FDI	ENGINEERING CHANGE ORDER		ECO NO: 12-119
			Page 1 of 2
TITLE	DWG NO.	CURRENT REV	NEW REV
uEZGUI4.3	uEZGUI4.3	5.1	6

BACKGROUND:

- Add ESD protection components to reset signals
- Change RTC battery diode to low drop, low leakage device

POWER-ON RESET CIRCUIT

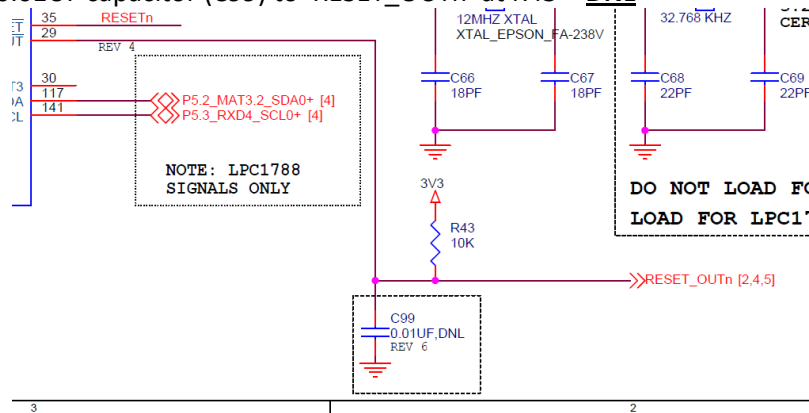
1. Add 0.1UF capacitor (C97) to 'RESET_Inn' at U12 pin 1
2. Add 0.1UF capacitor (C98) to 'RESETn' at U12 pin 4
3. Add 10K pullup resistor (R81) at U10 pin 1

4. Add optional 0.01UF capacitor (C99) to 'RESET_OUTn' at R43 – **DNL**

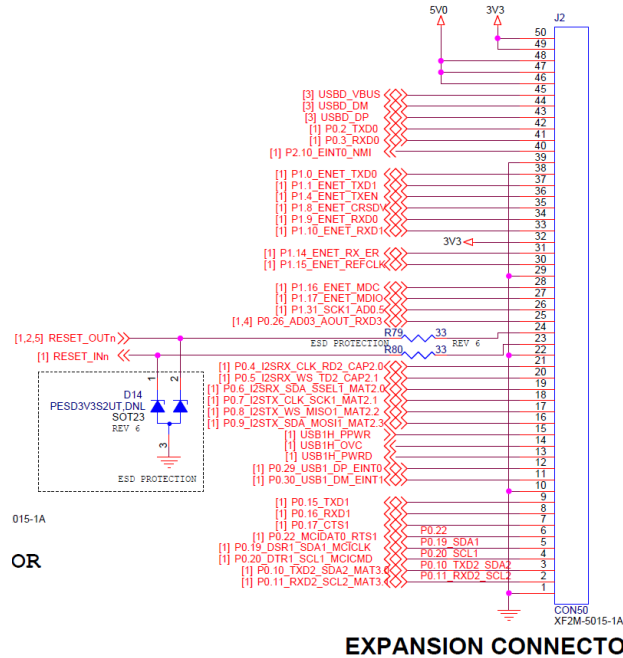
- Add 33ohm resistor (R79) in series to 'RESET_OUTn' to J2 pin 24
- Add 33ohm resistor (R80) in series to 'RESET_INn' to J2 pin 23
- Add OPTIONAL ESD protection diode, PESD3V3S2UT (D14) to 'RESET_OUTn' and 'RESET_INn' – **DO NOT LOAD**

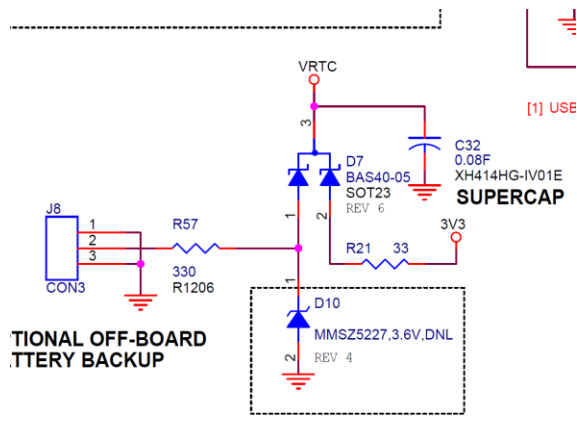
- Change D7 to BAS40-05
